Identification: A14 - N900 **Tech. Bulletin n°: PD2005-02**Date: 26-05-2005

Factory: PD-Vallenoncello Modular Cooking

Subject N900 PASTA COOKERS: NEW WATER

**SOLENOID VALVE**

## **NEW WATER SOLENOID VALVE**

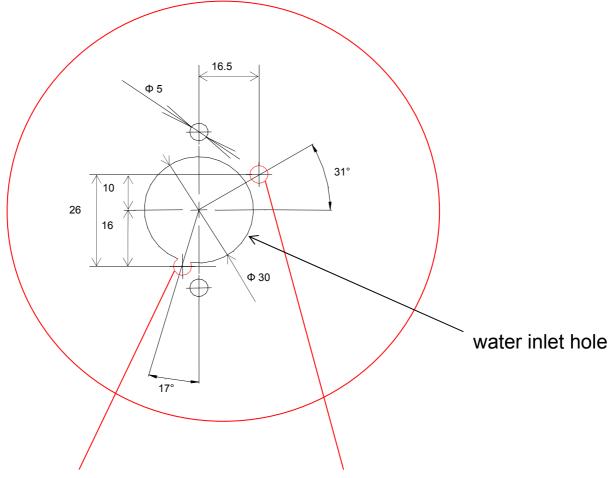
**Problem** The solenoid breaks in case of:

- lack of water in the main water supply net;

- hot water supplied to the pasta cooker.

**Reason** - The solenoid is designed for intermittent duty.

1. Water solenoid valve (new code: 0C2390);

Solenoid 'class F' Room temperature 80 °C

Body in brass

2 holes to drill: diameter 6 mm

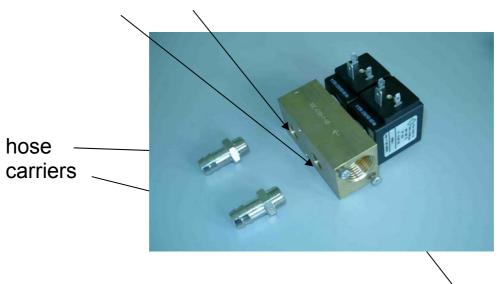
To replace the new water solenoid valve on equipments older than s/n 521... it is needed to run also the following modifications:

✓ **Bottom**: it is needed to drill 2 holes (diam. 6 mm) for fitting the valve round the main water inlet hole (see picture below);
